SUBJECT: 6th Floor Office Renovation/ Arlington High School

ADDENDUM NO. 6

ADDENDUM NUMBER SIX

6TH FLOOR OFFICE RENOVATION
ARLINGTON HIGH SCHOOL

SHEET NO:
SKM-2

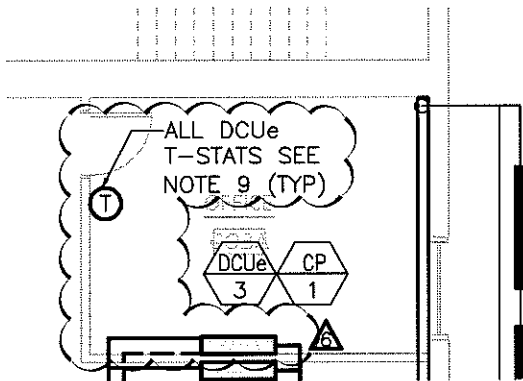
- AD6-1 DRAWING M0.1 – HVAC LEGEND SCHEDULES AND GENERAL NOTES:**
A. **Incorporate** the clarifications and/or revisions on the following sketch: SKM-2.
- DRAWING M1.2 – HVAC 6TH FLOOR VARIABLE REFRIGERANT FLOW AND PIPING LAYOUT:**
A. *Incorporate* the clarifications and/or revisions on the following sketch: SKM-3.
- DRAWING M3.1 – HVAC CONTROL DIAGRAM:**
A. **Note** drawing has been changed for HVAC re-bid. Updated drawing is included in the construction document.

SELECTION BASED ON "MITSUBISHI", PROVIDE WIRELESS TSTAT, LOW AMBIENT CONTROL AND INTERNAL MOUNTED CONDENSATE PUMP OF MODEL LISTED ABOVE. CPM BASED ON FANS SET AT LOW SPEED. PROVIDE WITH AIR COOLED CONDENSING UNIT AS INDICATED IN THE SCHEDULE. ALL REFRIGERANT TUBING SHALL BE SIZED BY UNIT MANUFACTURER. PROVIDE ALL NECESSARY JOINT KITS, FITTINGS AND ACCESSORIES FOR A COMPLETE OPERATING SYSTEM PER MANUFACTURER'S RECOMMENDATIONS. PROVIDE NECESSARY EQUIPMENT FOR FUTURE BMS SYSTEM INTERFACE. COORDINATE CONTROL PROTOCOL REQUIREMENTS WITH ATC CONTRACTOR SYSTEM SHALL BE CAPABLE OF HEATING OR COOLING SYSTEM CHANGEOVER.

IF ALTERNATE NUMBER 2 IS ACCEPTED FOR THE PROJECT THE CONTRACTOR SHALL PROVIDE THIS EQUIPMENT AND PLACE ON ROOF. CONTRACTOR TO COORDINATE LOCATION ON ROOF WITH OWNER. UNIT SHALL BE MOUNTED ON 4x4 FT SLEEPERS IN ACCORDANCE WITH THE MANUFACTURER'S RECOMMENDATIONS. OWNER SHALL BE RESPONSIBLE FOR CONNECTING EQUIPMENT INTO EXISTING SYSTEM.
